BULLETIN: #T-62-10

DEPT: Service and Parts

SUBJECT: PLUNGER RETAINER (RACK & PINION ASSY.)TRIUMPH HERALD

BOSS TAPPING DETAILS.

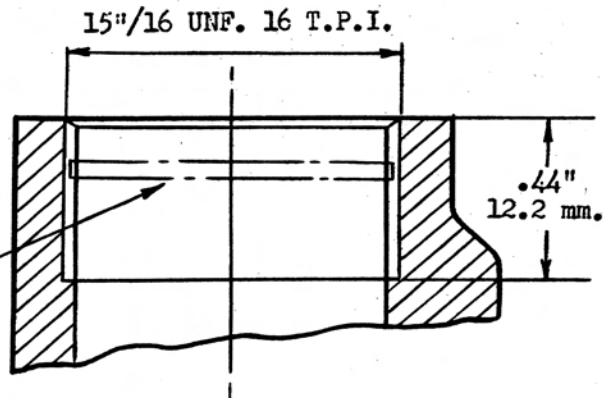
This method of securing plunger may be incorporated on Part Number 205628 and 304737 when serviced for complaint of circlip not holding in position.

CIRCLIP SLOT.

1. Remove and dismantle the steering unit as described in the Service Manual (Group 4).
  2. Tap the plunger boss housing to a depth of - .44" (12.2 mm). using a 15/16" UNF. 16 TPI tap.
  3. Thoroughly clean the housing and pack with the correct grade of grease when refitting the rack and pinion.
  4. Fit new plunger 120946; spring 126765; and screwed cap 132053; placing two packing washers 133745, and sufficient shims 120949 and 120959 between the cap and housing to obtain correct end float.
- NOTE: The end float should be between .004" to .008" (0.1 to 0.2 mm) or the minimum amount consistent with free movement from lock to lock.
5. Refit the steering unit.

Use shims 120949 and 120959 as required to give 0.004" - 0.008" (0.1- 0.2 mm.) plunger end float.

PACKING  
WASHER 133745.

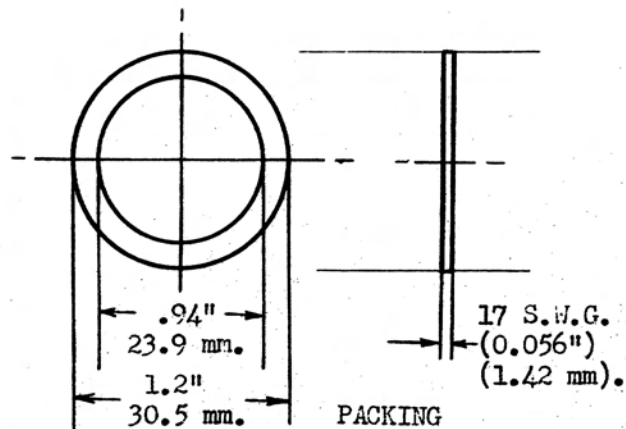
Some steering units incorporate a circlip and spring plate to retain the plunger in the rack and pinion assembly. Should circlip failure occur, modify the unit to the current screwed cap and spring method of retaining the plunger, as illustrated overleaf and described below:
